Improved Definition of CRU (Comments 151, 152, and 153)

IEEE 802.3dj July Meeting

July 13, 2026

Wide Varieties of CDR Implementations

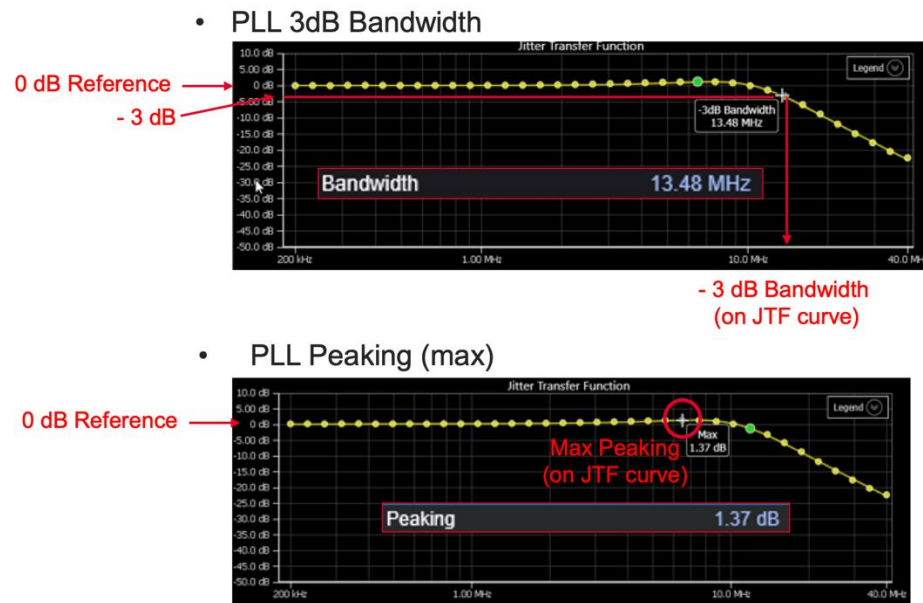
❑ Jitter Transfer Function (JTF) of several 56 GBd CDR's were investigated by [calvin 3dj 01a 2411](#)

- A Retimer (CDR) has a JTF BW of 13.48 MHz with 1.37 dB peaking – 2nd/3rd order PLL with 1.37 dB jitter peaking has good tracking but high BW may result in excessive jitter generation
- A Retimer (CDR) with dual has tracking BW of 2 MHz may fail input JTOL while having excellent jitter transfer BW 42 kHz – 1st order PLL has no jitter peaking and excellent jitter transfer but 2 MHz tracking may fail input JTOL.
